**PRE-DESIGN TECHNICAL MEMORANDUM**  
**MADRID STORMWATER AND EROSION SAFETY PROJECT**

SHARE No. 19-521-0620-0160  
Task Order No. 1

August 1, 2019

## **PRE-DESIGN TECHNICAL MEMORANDUM MADRID STORMWATER AND EROSION SAFETY PROJECT**

Figure A-5. Plunge Pools in the Ice-House Road Area

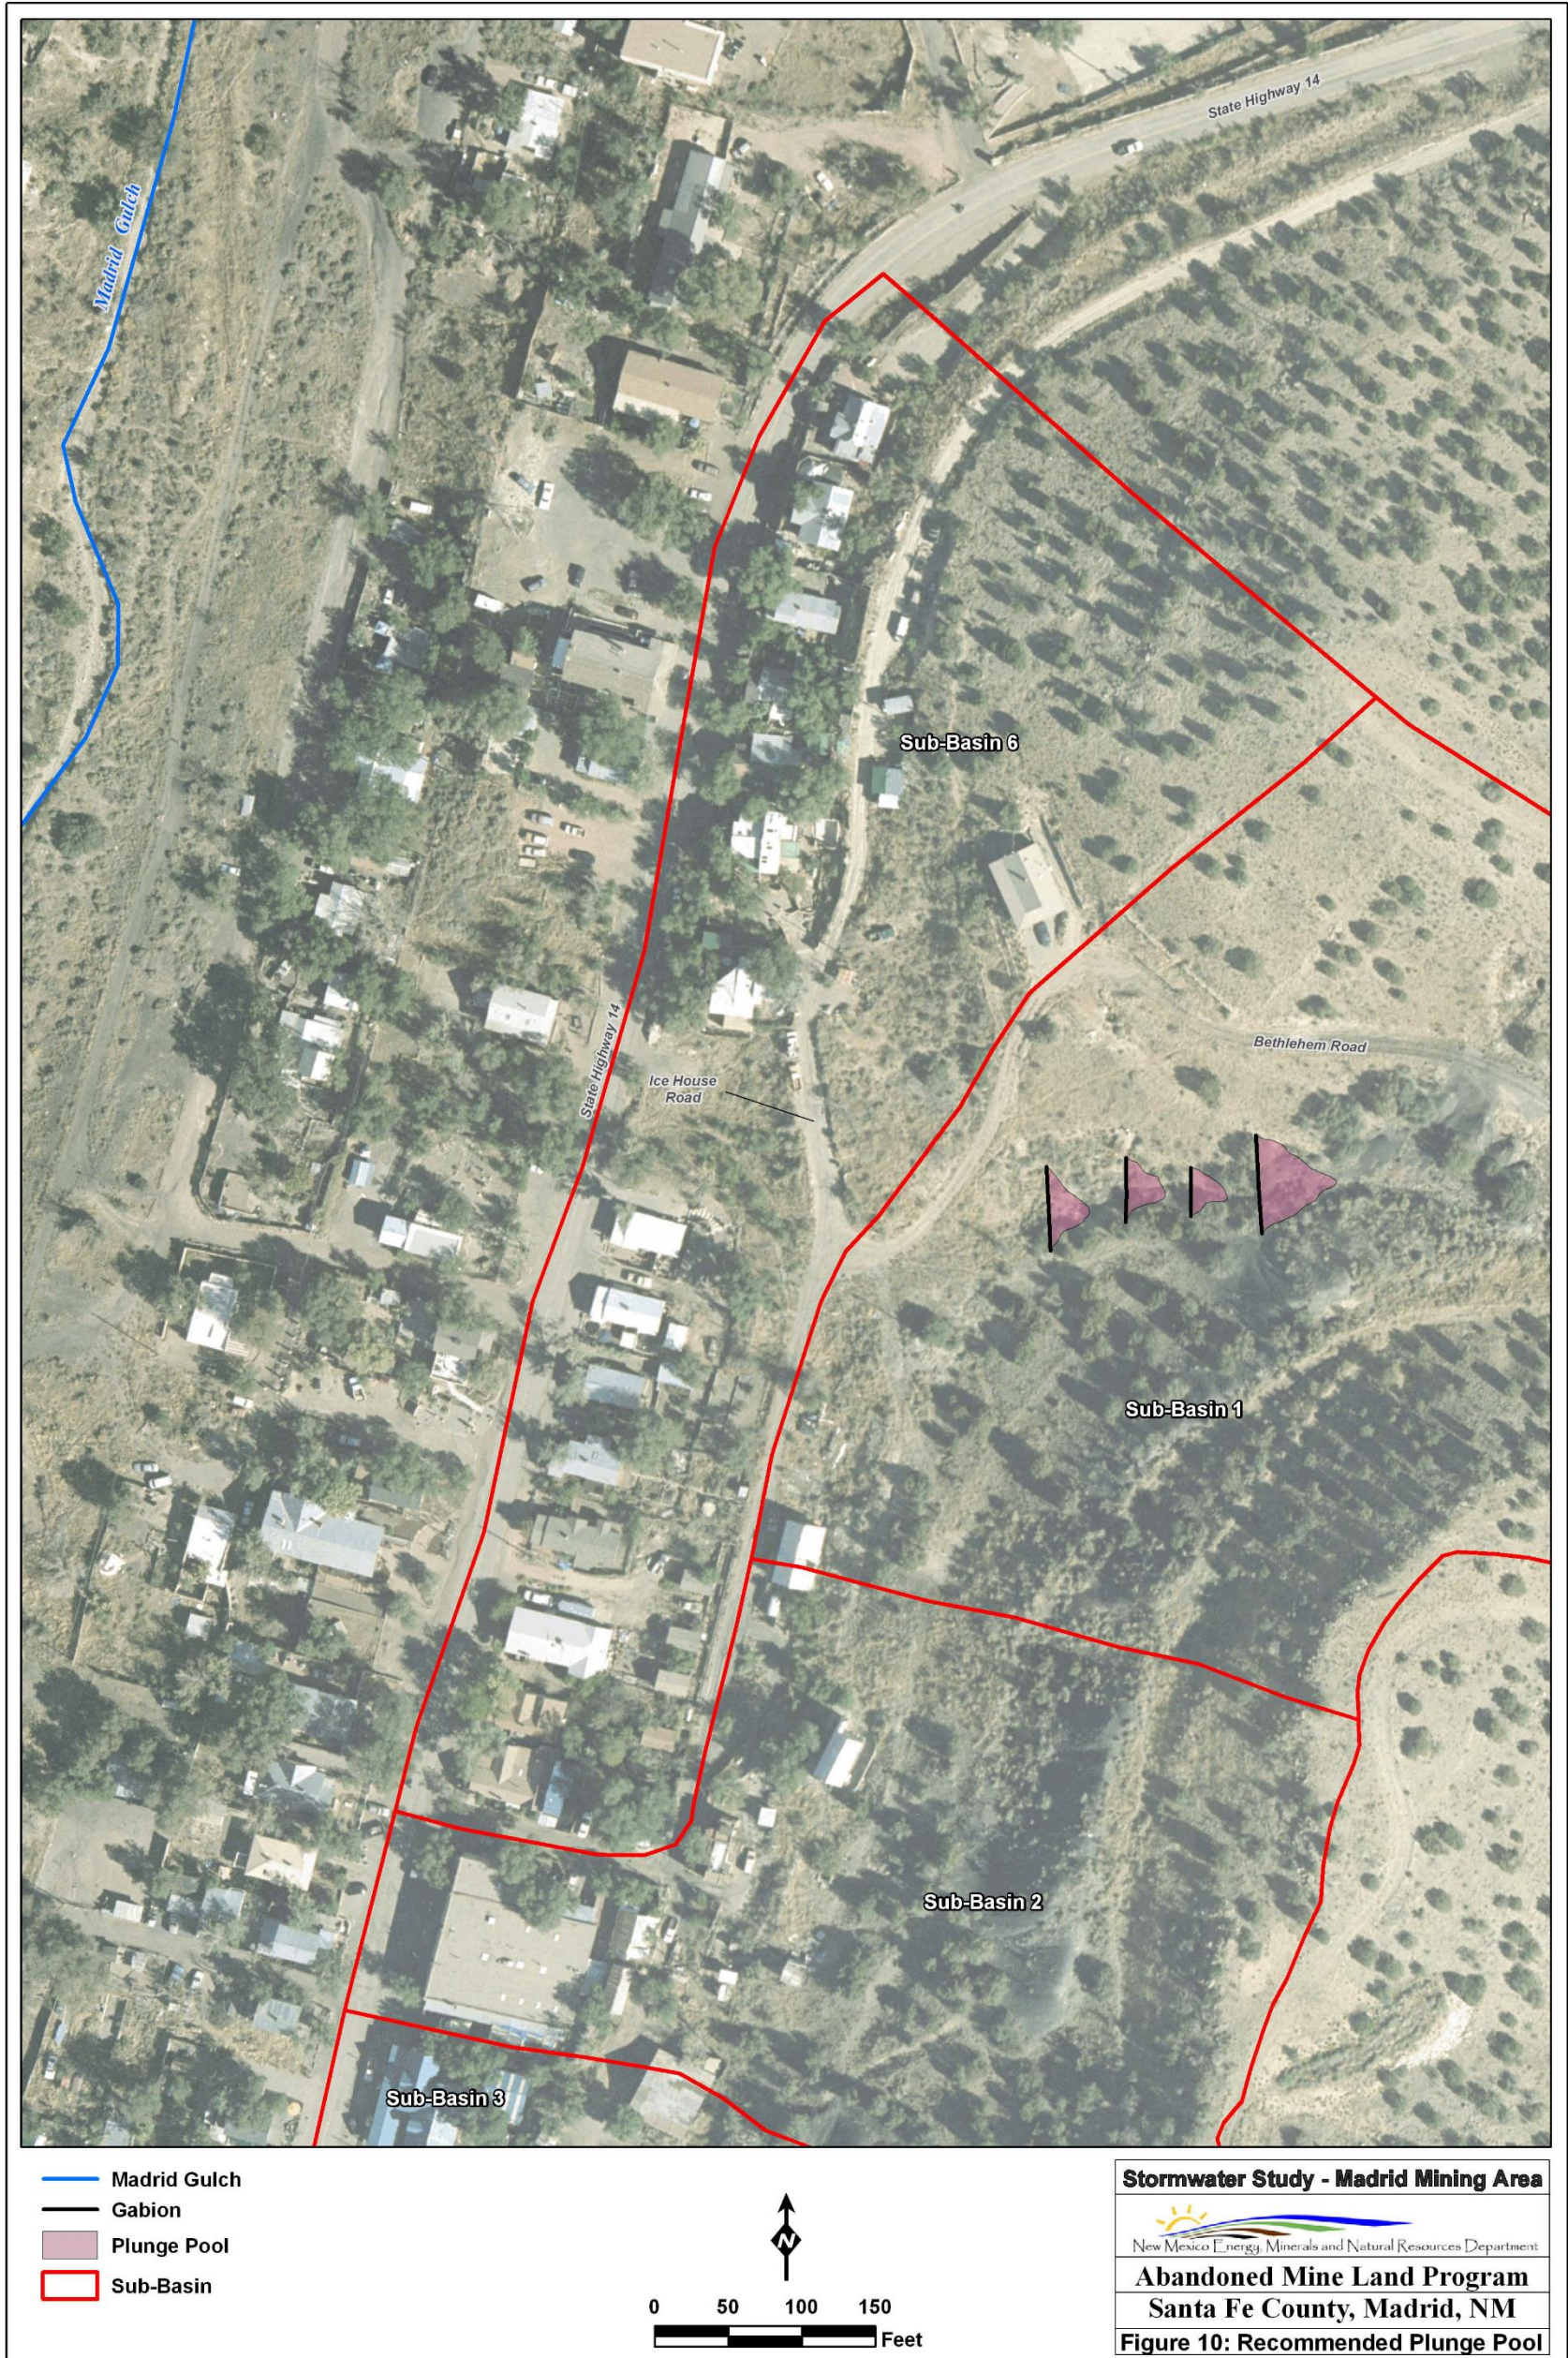
- Incorporate plunge pools as energy dissipation structures to control erosion. The stated storm water flow reduction benefit is considered negligible.
